**CITY OF ROSEVILLE  
PLANNING DEPARTMENT STAFF REPORT  
PLANNING COMMISSION MEETING December 8, 2005**

**ITEM V-A: MAJOR PROJECT PERMIT (STAGE 1) – 290 CONVENTION CENTER DRIVE (NCRSP PARCEI  
40A) – ROSEVILLE HOTEL CONFERENCE CENTER - FILE #: 2005 PL-076 (MPP-000002)**

Stage 1 approval of a **Major Project Permit (MPP)** to construct a 35,000 square foot conference facility, a ten story Embassy Suite hotel with 279 rooms, a second multi-story hotel with 221 rooms, two freestanding restaurant pads (10,000 s.f. each), and a parking structure. Stage 1 of the MPP application consists of the approval of a preliminary development plan.

**CONCEPTUAL SITE PLAN**  
SCHEMATIC SITE PLAN

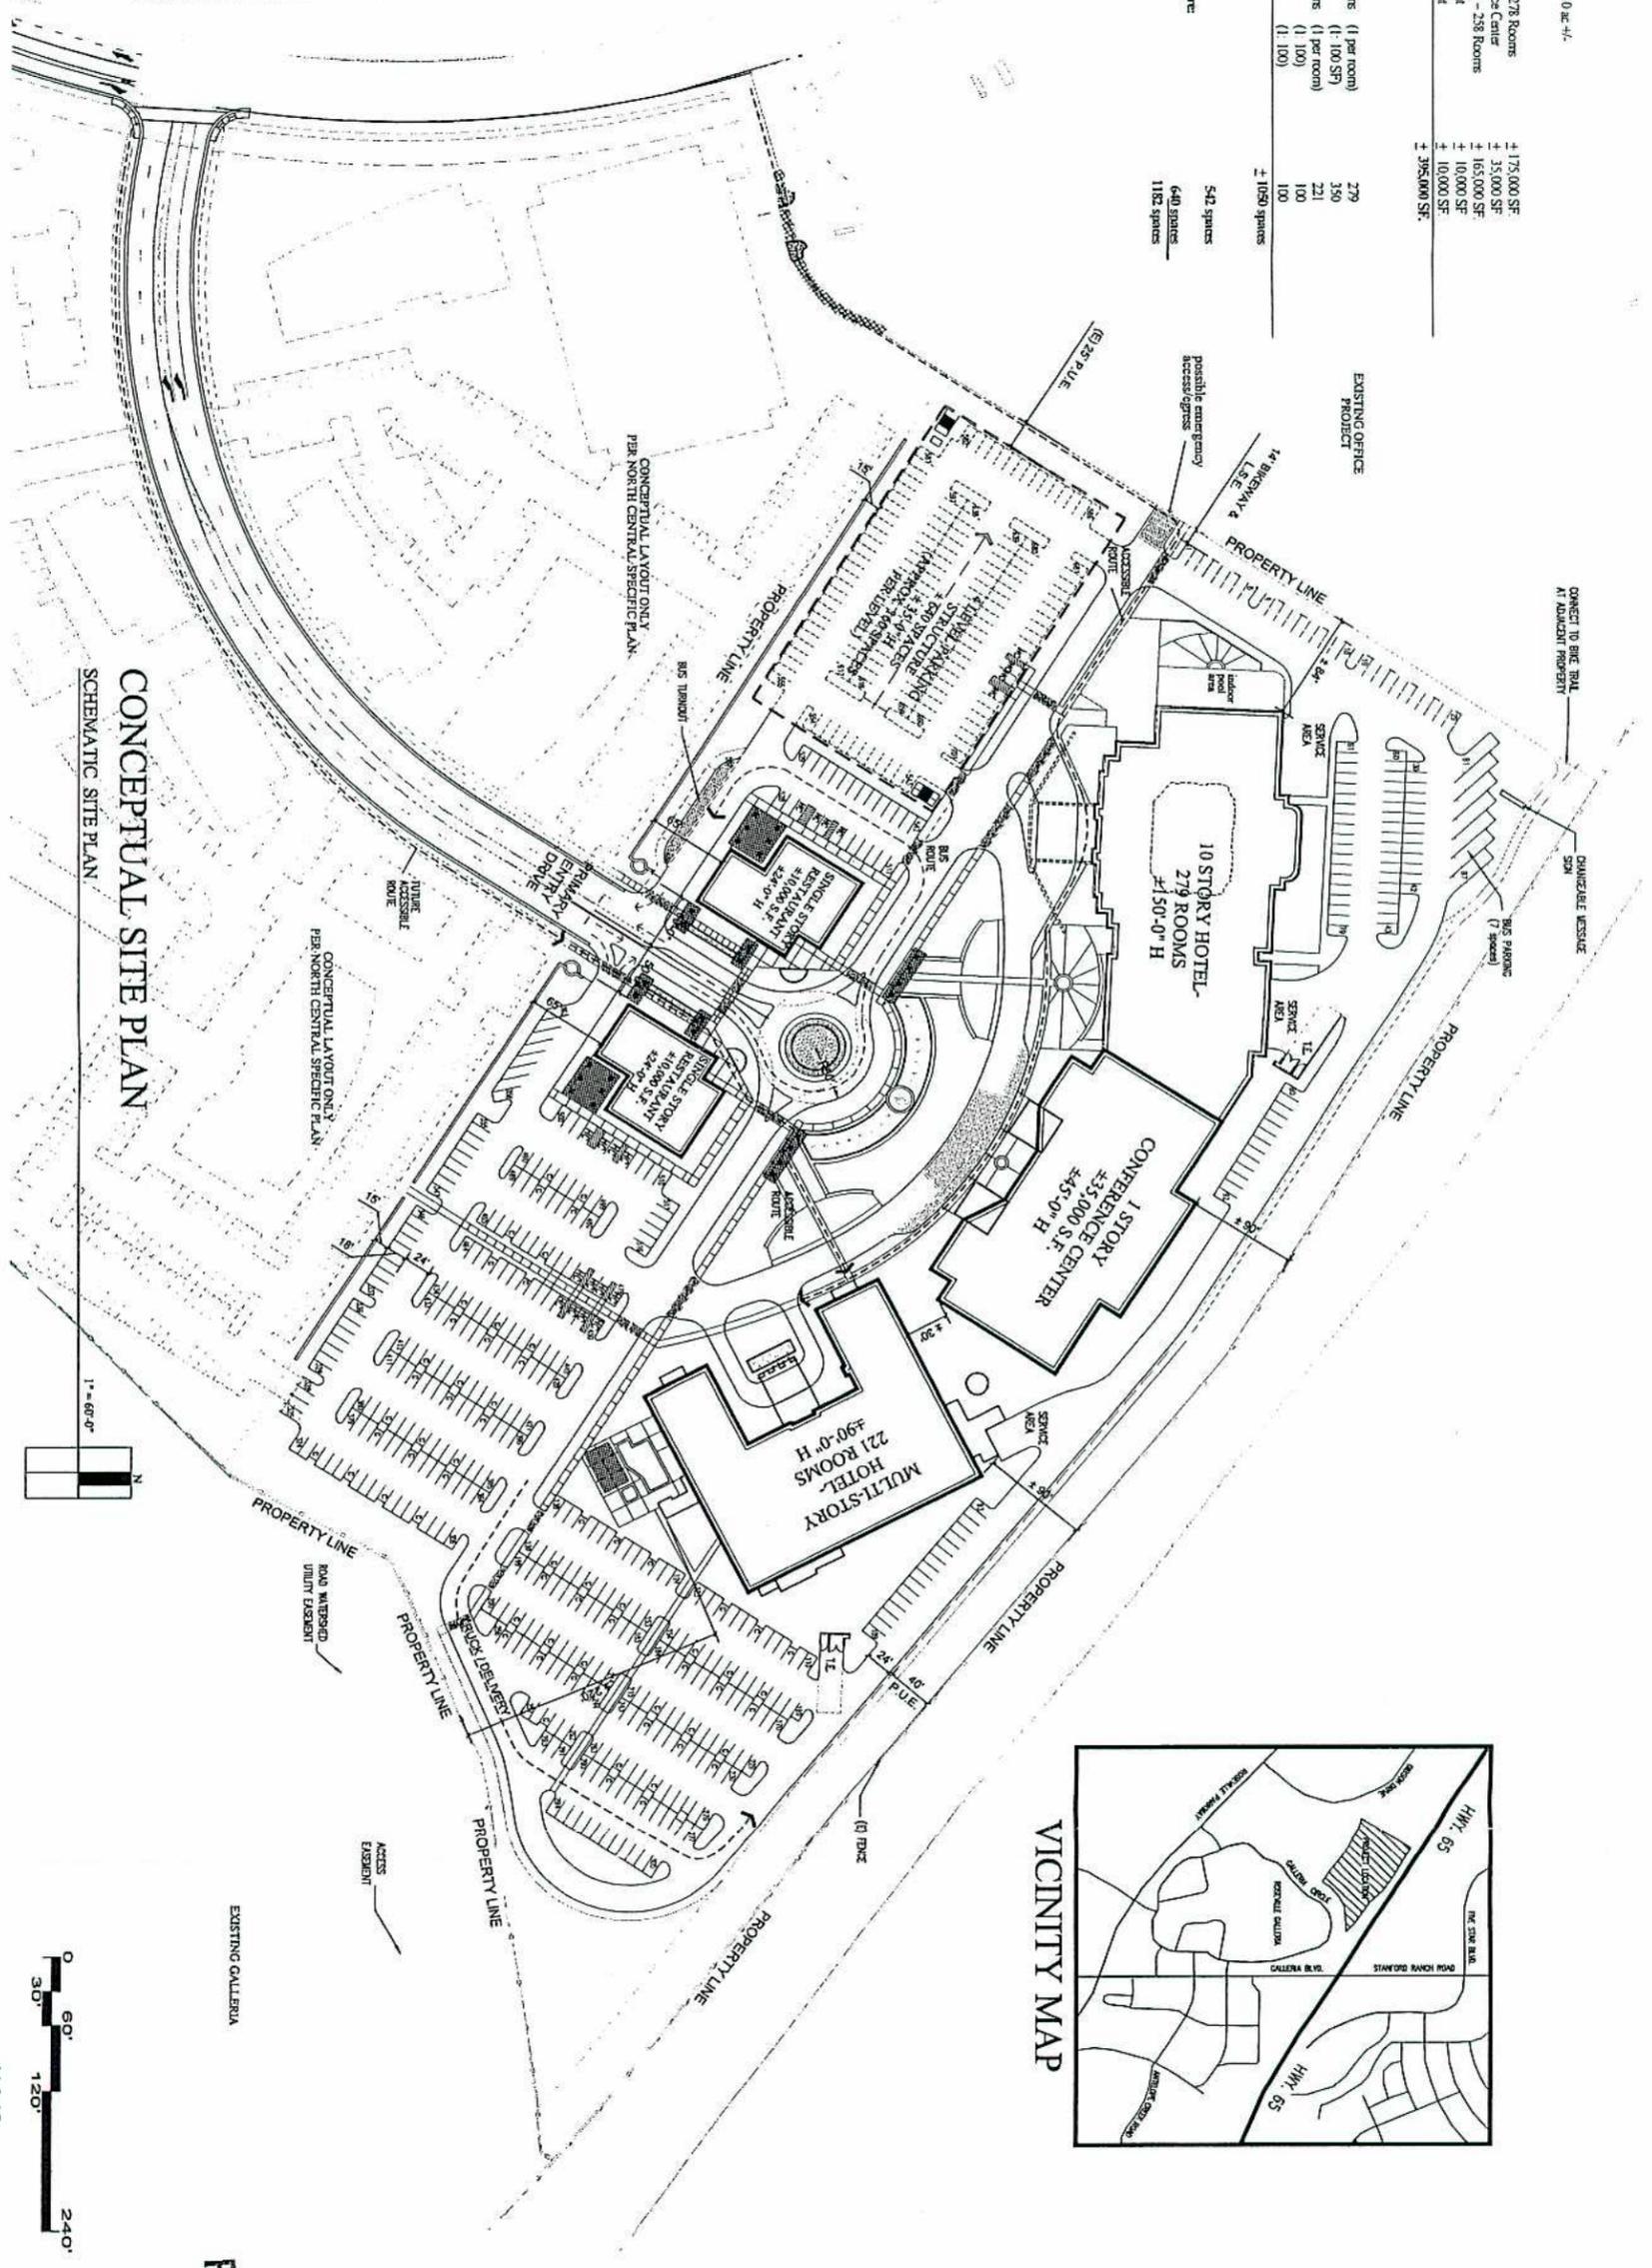
9. Parking spaces 9-18 and 26-29 shall be reduced in length by two feet and converted to compact size to provide an increased setback from the bike trail. (Planning, Transportation, Engineering)
